WCC Housing Detailed Seismic Assessments

Berkeley Dallard – Detailed Seismic Assessment

Wellington City Council

Appendix I – Beca Peer Review Letter

Figure 4-4 Grillage model of Level 8 for the South Building

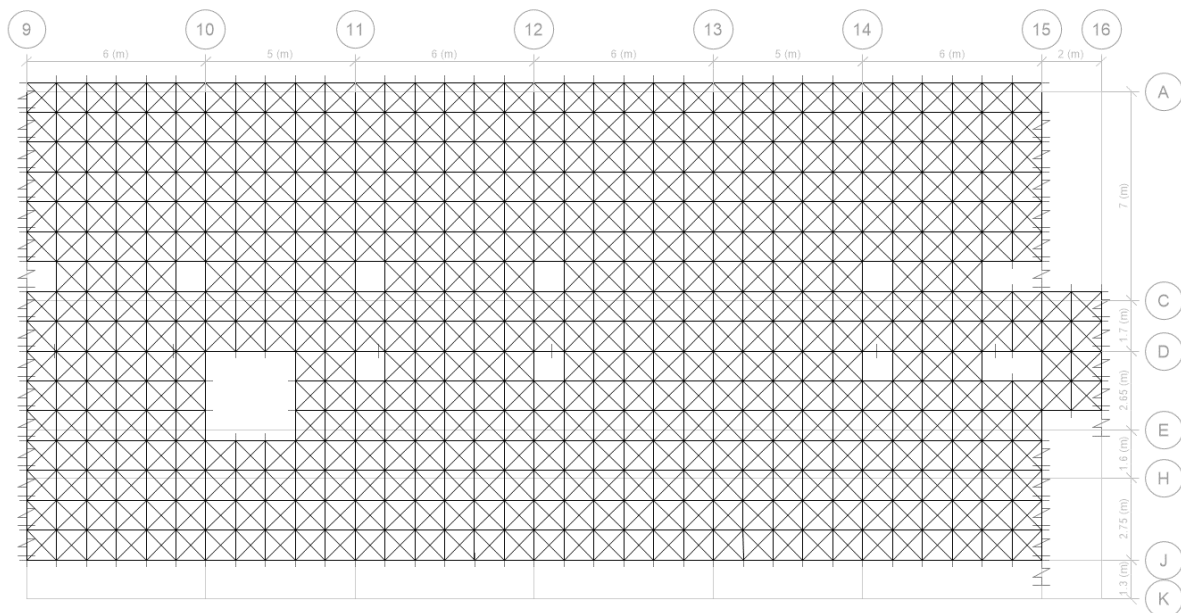
3.3	RC Diaphragm Assessment	For diaphragm loading in the longitudinal direction, we would expect to see some degree of symmetry across the building (about the blue line below) rather than the significant asymmetry that we are seeing. Do you have an understanding of why this is happening? 	With reference to Strengthening Drawing S.25.009, it can be observed that during strengthening, a new 250mm thick wall was added to the existing 8" thick wall along Grid G. This converted the wall to an 8.7m, 450mm thick wall and by far the stiffest element over the entire floor plate in the longitudinal direction. Therefore, as expected the wall absorbed the load and the distribution of floor tie loads is asymmetric.	While we recognise that the strengthened wall will be very strong, the forces in the diaphragm are still highly asymmetric, and do not appear to align with all of the force tracking to one elements. For example, why are the orthogonal elements in compression at GLA but in compression at GLK for loading in the x direction. We would expect these to be similar and at least the same direction (comp or tens)	The reason for having the large force in GLA lies in two facts: 1) Due to having the thick wall on grid E. More specifically, while most of the load is being channelled to this wall, an inclined strut should form as below. The force in the strut is resisted by the tie elements on GLA and GL9. 2) Spandrel beams exist on GLA and GLJ. These axially stiff elements also tend to grab larger force as compared to other tie elements. 3) The building response is torsional due to the what's explained earlier and also by considering the effect of the transfer forces from the level above, this is explained further in 3.4. 	Noted, no further comments	CLOSED

Figure 5-12, 6" RC Shear Wall Stress Distribution Based on Out-of-plane Seismic Parts Loading

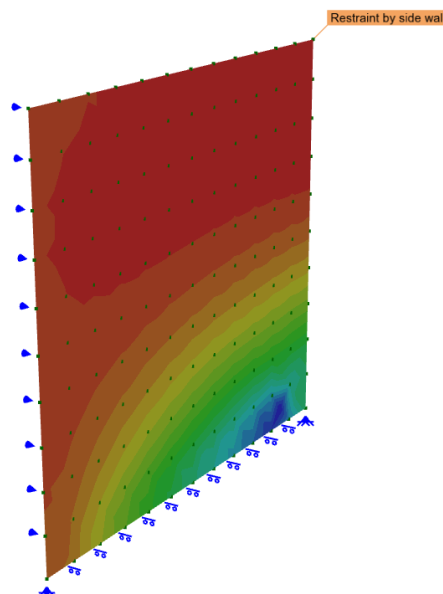
We raised some comments with Aurecon around the support conditions to the reinforced concrete walls above level 9. On the basis that Aurecon have rated the post-installed diaphragm and roof connections at <34%NBS and unable to provide restraint to the reinforced concrete walls out of plane. Accepting Aurecon's view on the diaphragm connections (as discussed above) we agree that the walls have insufficient capacity to cantilever out-of plane with parts loading.
